# TECHNICAL SERVICE BULLETIN

## Water Leak Onto Front Carpet From A-Pillar

**22-2242**

<b>Ford</b> 2015-2022 Mustang
----------------------------------

Figure 1 - Left A-pillar shown, right A-pillar similar

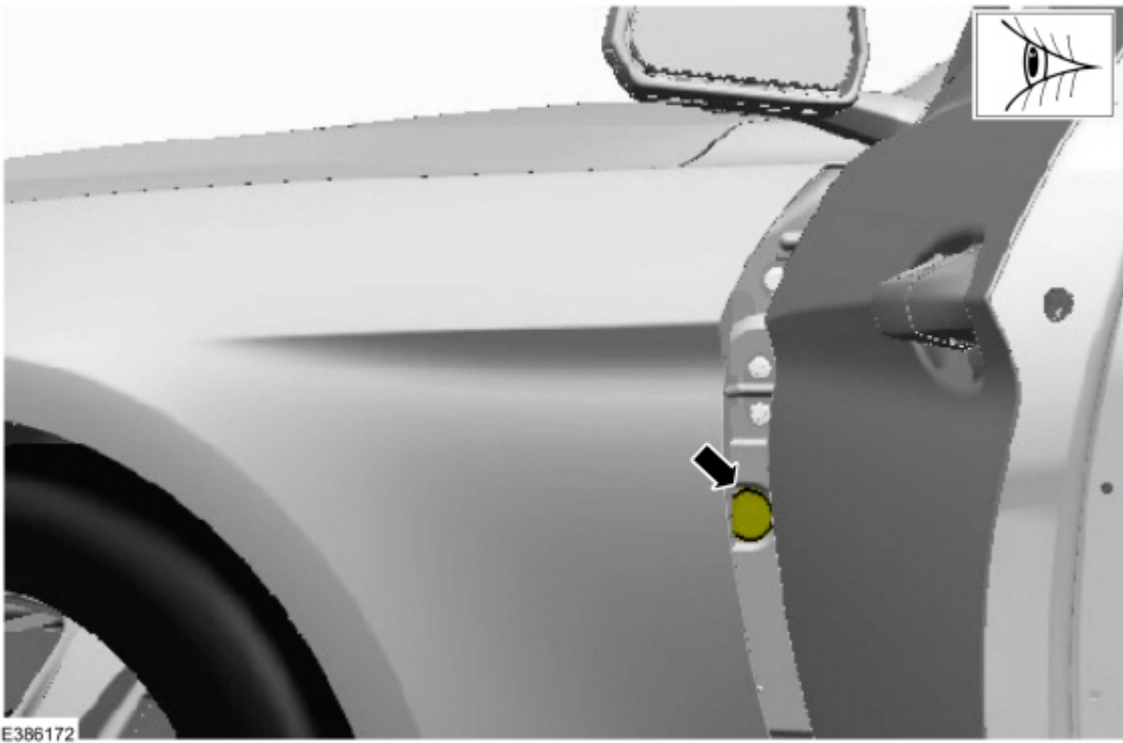
1. Fully open both doors.
2. Inspect the body seals on both A-pillars for complete 360-degree adhesion to the sheet metal. (Figure 1)

**NOTE: The A-pillar body seals are an adhesive patch that seals a 19 mm (0.75 in.) diameter hole in the sheet metal. These seals must have complete adhesion around all edges. If any portion of the sealing surface is compromised, water entry into the cabin may result.**

Figure 2 - Example of failed A-pillar sticker seals

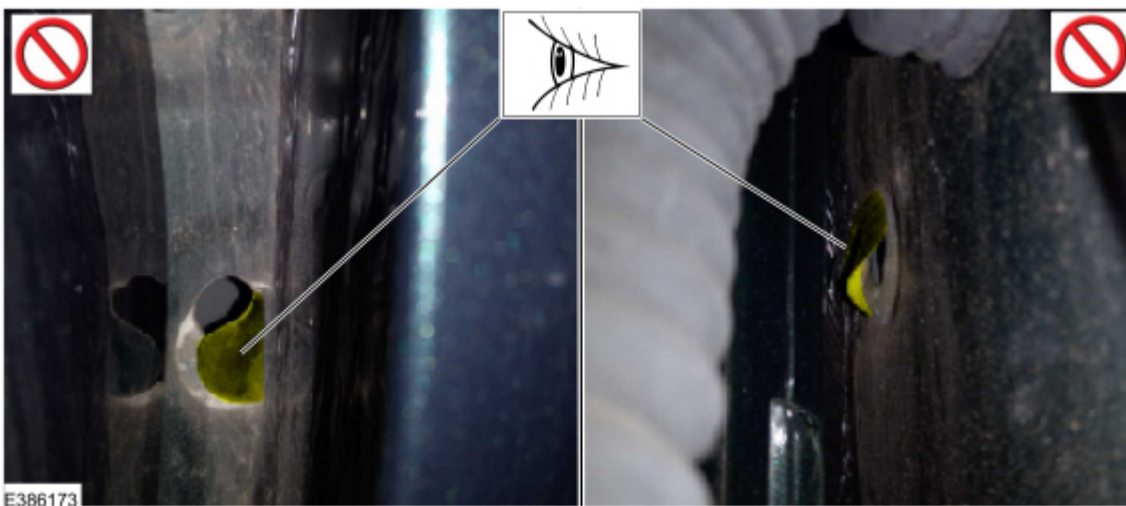
3. Are the body seals on both A-pillars completely sealed to the body? (Figure 2)

- (1). Yes - this article does not apply.
- (2). No - proceed to Step 4.
4. Inspect the fender insulator to be sure it does not restrict access to the A-pillar body seal. If the fender insulator covers any portion of the A-pillar body seal, the foam fender insulator can be slightly indented to allow for unobstructed access to the seal.
5. Apply paint-safe, protective tape to the door and fender edges.
6. Use fingers and/or pliers to completely remove and discard the A-pillar body seal.

7. Use alcohol wipes to remove all remaining adhesive left by the discarded body seal.
8. Apply Motorcraft® Anti-Corrosion Coating to all exposed metal around the A-pillar body hole. Allow the Motorcraft® Anti-Corrosion Coating to dry following the instructions on the container.
9. Use a small paint brush to apply touch-up paint to the exterior surfaces that were previously coated with Motorcraft® Anti-Corrosion Coating. Allow paint time to dry following the instructions on the touch-up paint container.
10. Install and fully seat the new rubber body plug into the A-pillar body hole.
11. If the other A-pillar body seal requires repair, repeat Steps 4-10.
